Waterside House, Uxbridge

Facade Application

Project Title:	Waterside House, Uxbridge
Project Ref:	1153
Report Title:	Facade Alterations Application
Report Ref:	P933
Revision:	0
Date of Issue:	September 2022
Purpose of Issue:	Information
Compiled By:	Beatriz Antuna Tentor
Reviewed By:	Ben Paterson
Review Date:	12-09-22
File Location:	-

East Elevation Consented REF: 40050/APP/2021/1954

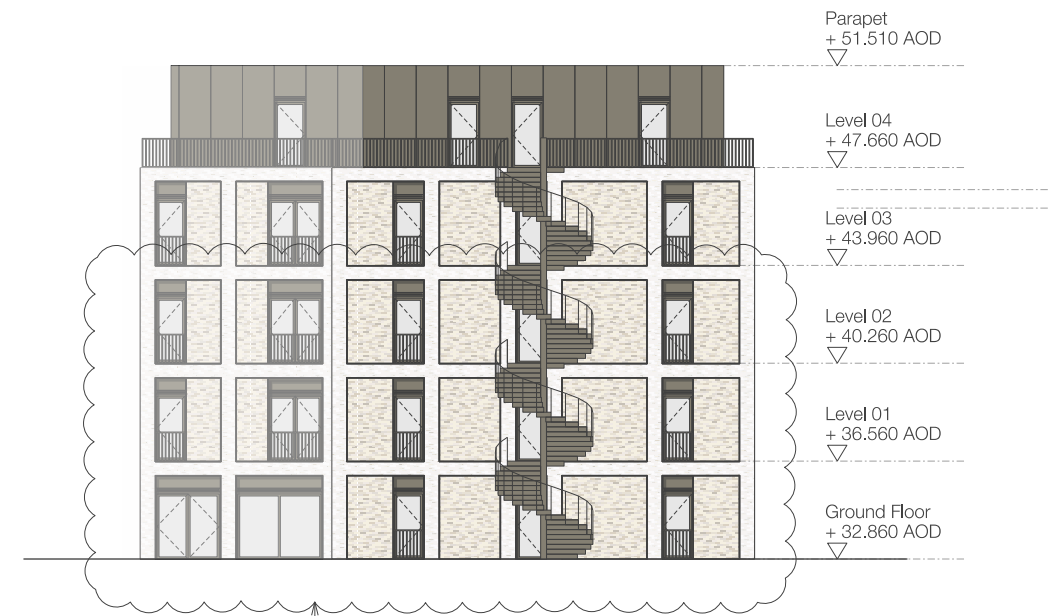
- The consented scheme (reference DAS and associated drawings) proposed a planar façade, where the white horizontal and vertical grid was set flush with the cream bricks located either side of the inward opening door. The transition between the white and cream bricks was highlighted through a "A 25mm wide metal profile separates this frame from the creamy infill brick panels and full-height Juliet windows".

- The proposed and 'punctured' arrangement of the windows/ balcony doors and cream bricks seeks to maintain the strong white horizontal and vertical banding established within the consented application.

- As a result of the existing levels and structure, modifications to the heights of windows/ balcony doors have been made when compared with the consented scheme.

- These existing constraints result in a slight adjustment to the vertical and horizontal white brick grid with a slight variation in which the two outermost vertical brick piers becoming 4 bricks wide where all horizontals are now 11 bricks high with exception of the course between ground and first floor which is 9.

- The Consented Approach of achieving the contrast between the white and cream bricks is no longer provided by the "25mm wide metal profile" but by recessed cream bricks which exaggerate the impression of a punctured facade. The decision to approach this in a different manner has been informed by buildability issues this detail would present in addition to a lack of built examples. Moreover the detail, particularly at the head condition would have presented issues with maintenance where the cream bricks would have become stained being set within the same plane as the white bricks above.

- Highlighted adjacent and in red are the areas of the facade where the arrangement of windows has been modified to suite the replanning of internal apartments and the position of existing structures.

West Elevation Consented REF: 40050/APP/2021/1954

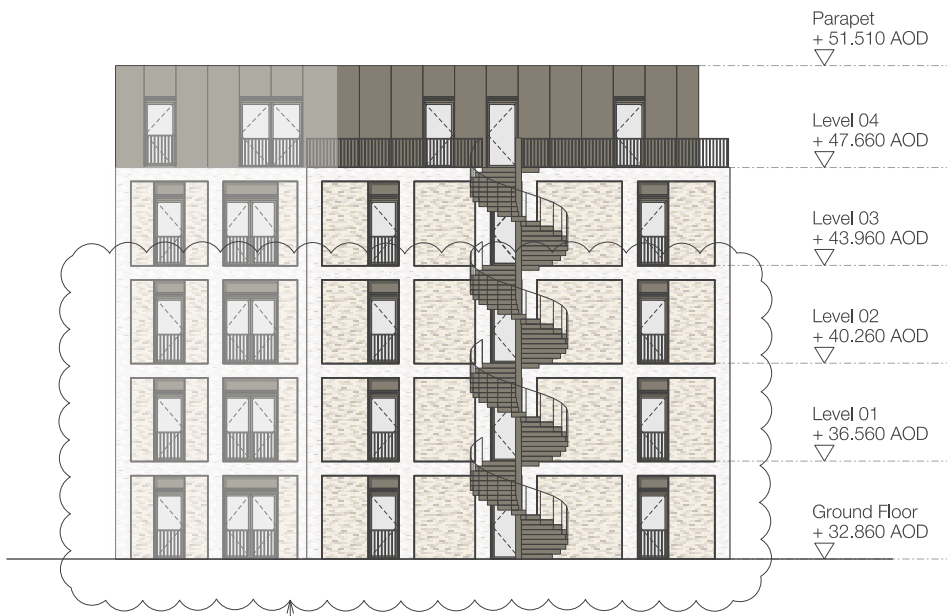
- As a result of the existing levels and structure, modifications to the heights of windows/ balcony doors have been made when compared with the consented scheme.

- These existing constraints result in a slight adjustment to the vertical and horizontal white brick grid with a slight variation in which the two outermost vertical brick piers becoming 4 bricks wide where all horizontals are now 11 bricks high with exception of the course between ground and first floor which is 9.

- The Consented Approach of achieving the contrast between the white and cream bricks is no longer provided by the "25mm wide metal profile" but by recessed cream bricks which exaggerate the impression of a punctured facade. The decision to approach this in a different manner has been informed by buildability issues this detail would present in addition to a lack of built examples. Moreover the detail, particularly at the head condition would have presented issues with maintenance where the cream bricks would have become stained being set within the same plane as the white bricks above.

- Highlighted adjacent and in red are the areas of the facade where the arrangement of windows has been modified to suite the replanning of internal apartments and the position of existing structures. On the ground floor the Juliet doors will be provided with direct access to the external grounds and secluded gardens with river views, this results in the omission of balconies which are no longer required.
